**Clark Fork Library Expansion/Remodel  
 East Bonner County Free Library District  
 Clark Fork, Idaho**

**ADDENDUM NO. 1**

**July 22, 2010**

**Sheet A8.01**

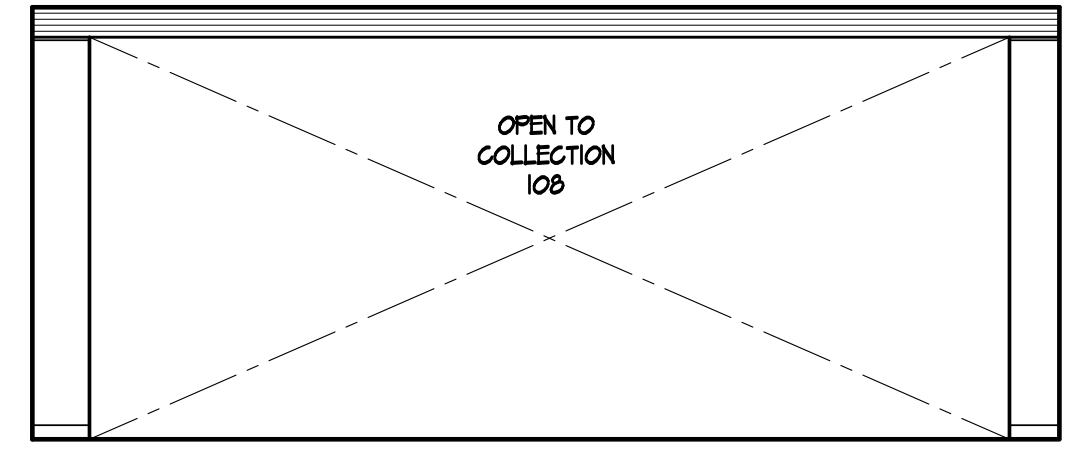
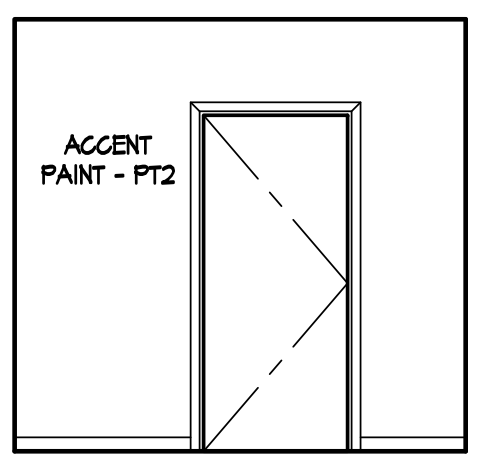
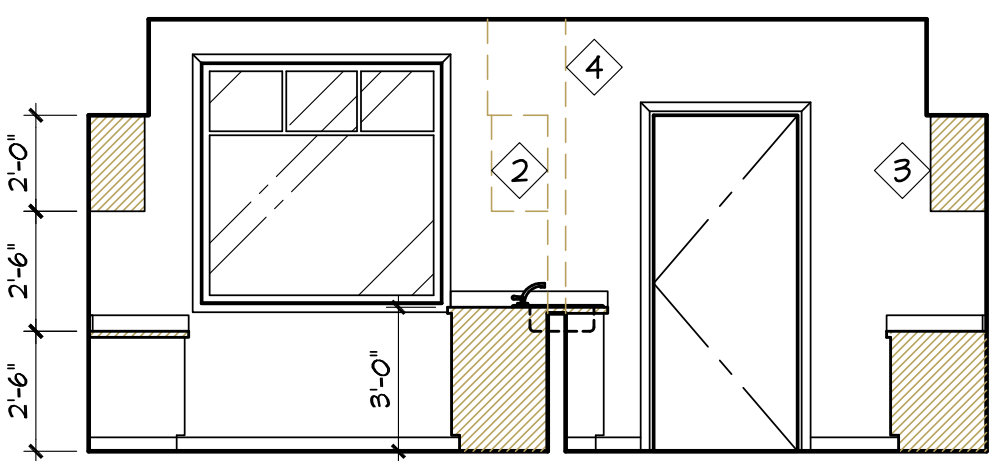
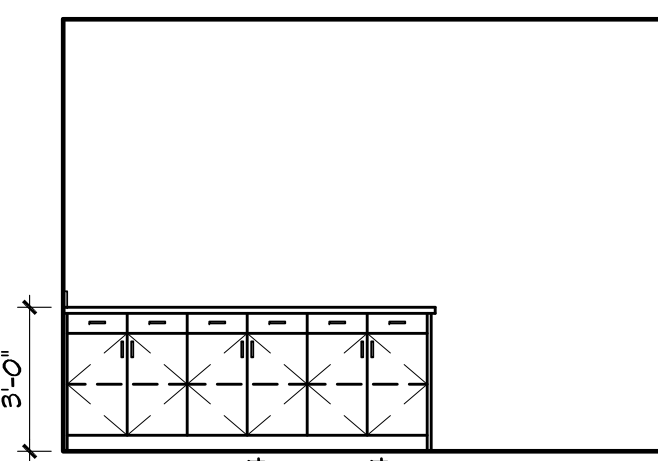
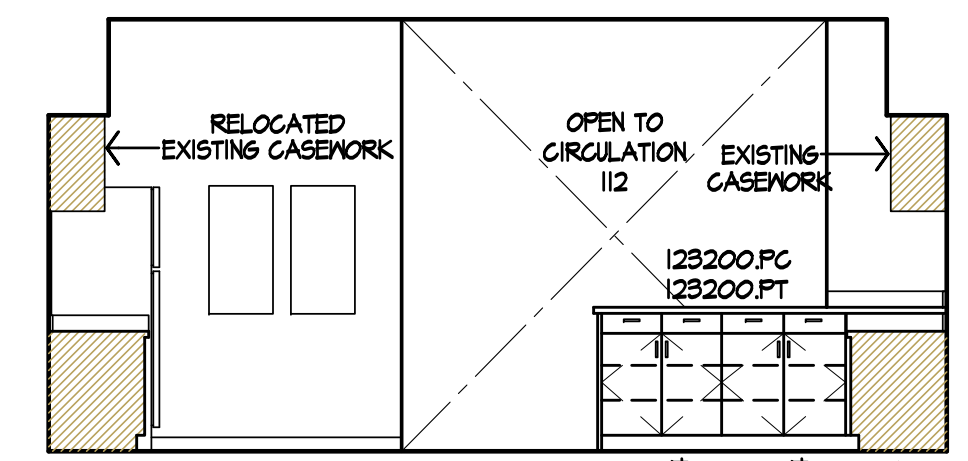
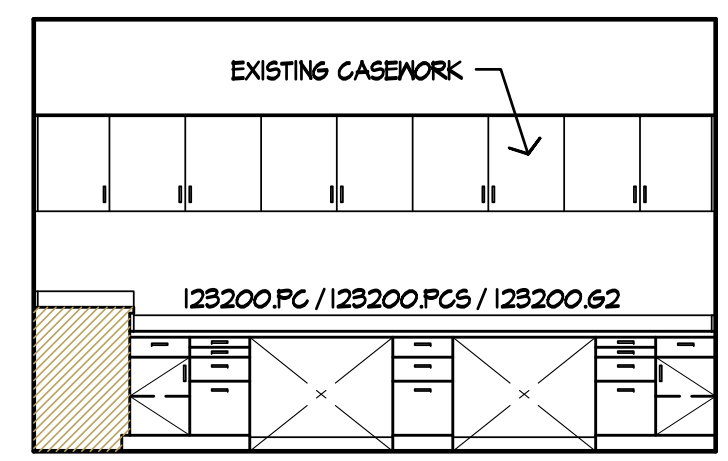
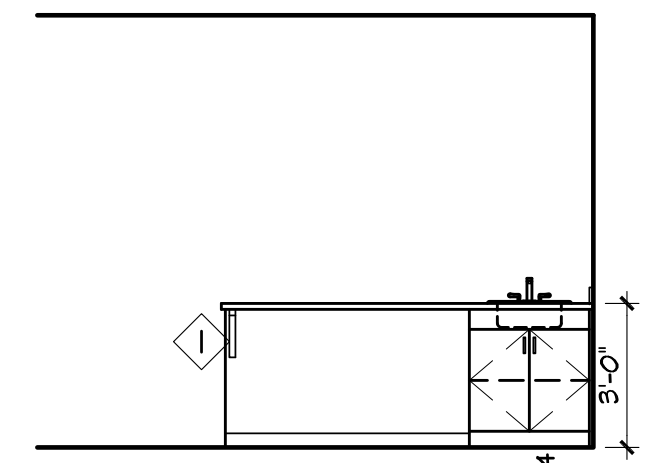
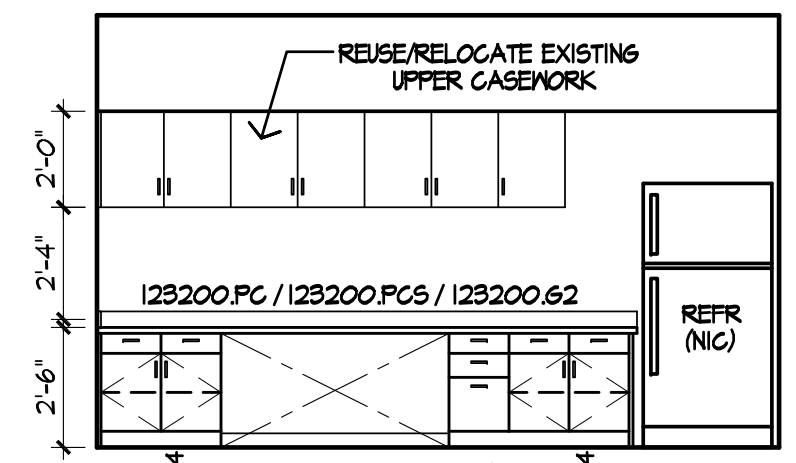
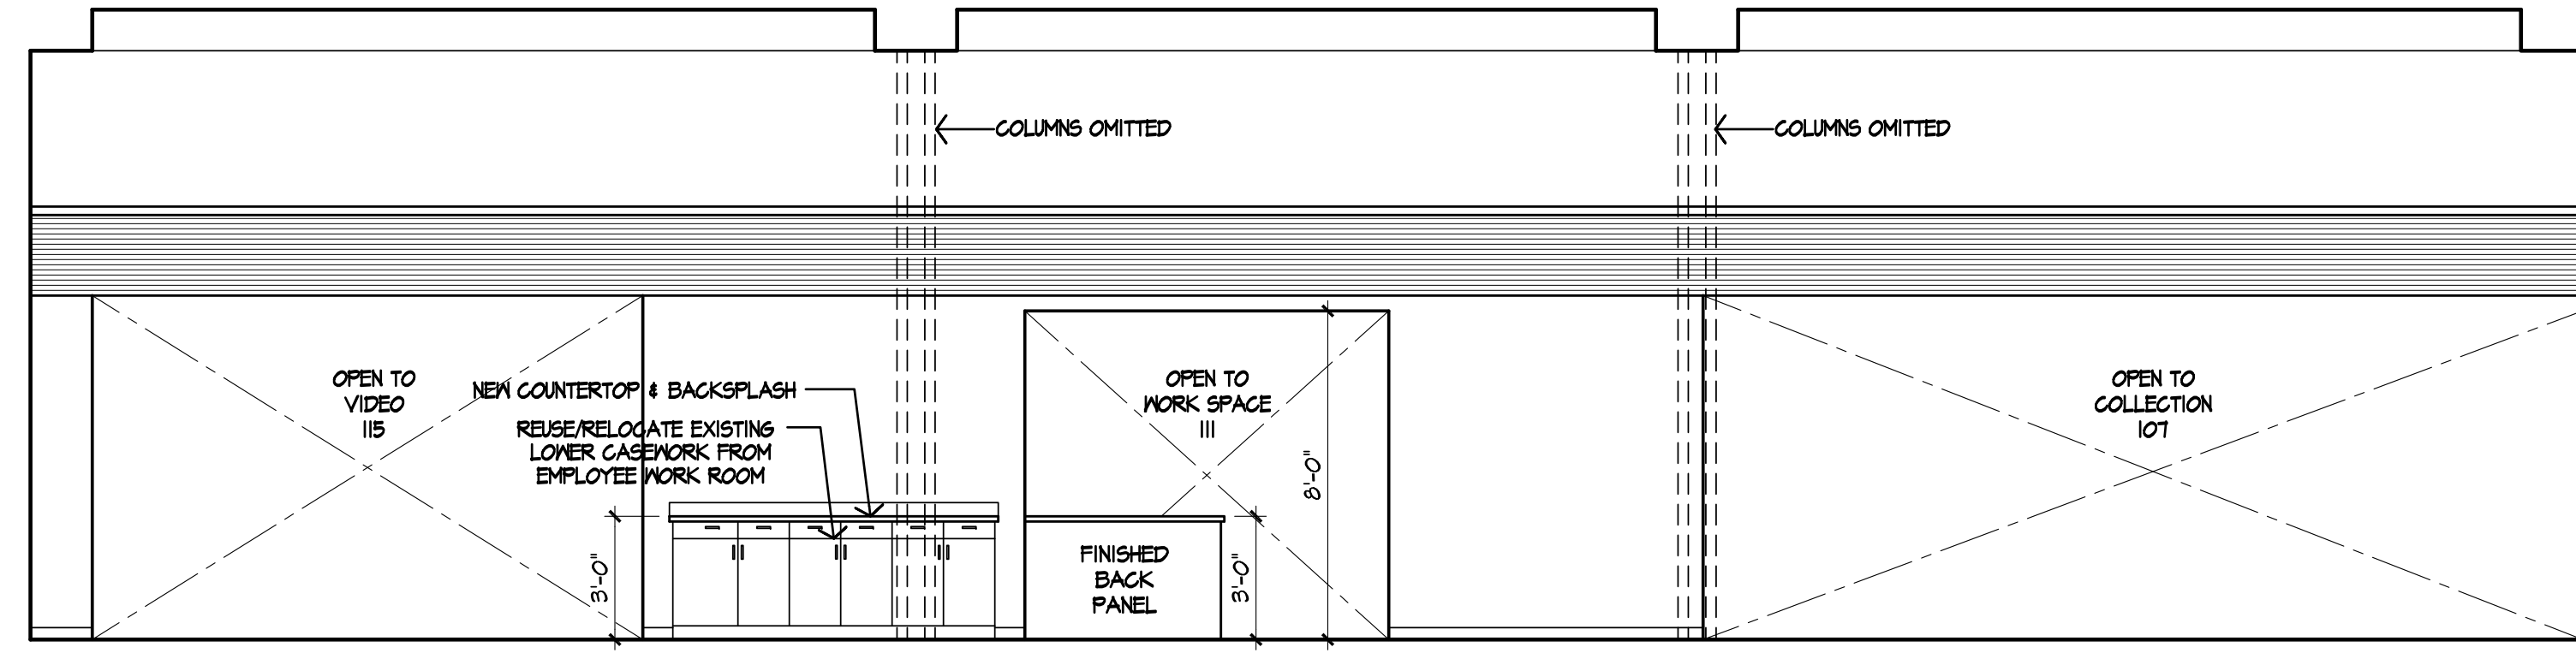
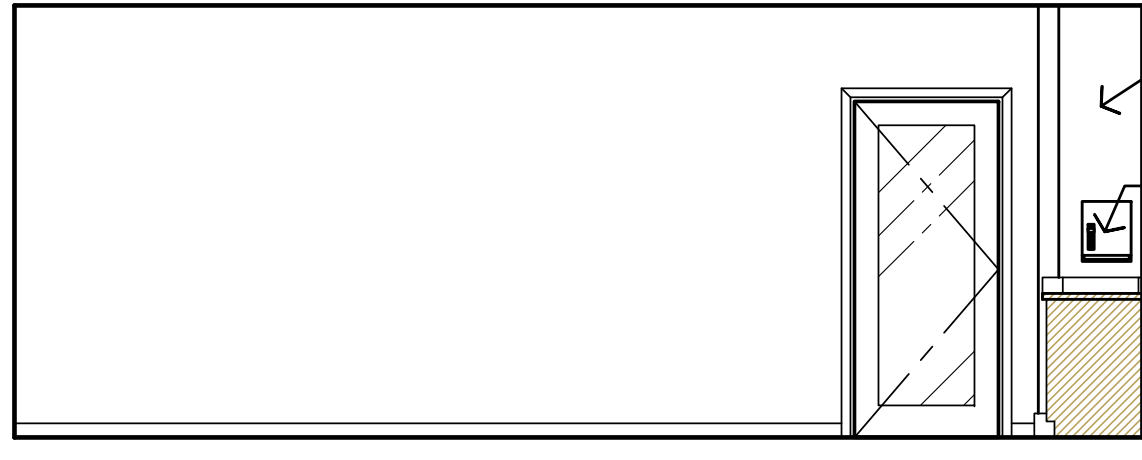
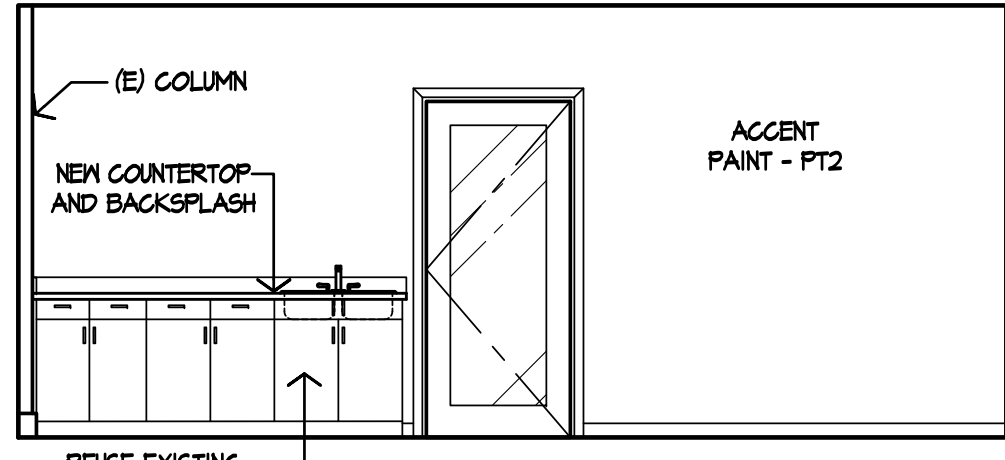
1. Conversion error resulted in the omission of information from the sheet. Replace sheet in its entirety per attached.

1. Interior Elevation Note 112/A8.01 (Circulation 112) is incorrect. The elevation is shown contiguous with elevation 116/A8.01.
2. Work Space 111 – Project east wall, upper casework does not extend over refrigerator location. Refer to interior elevations.
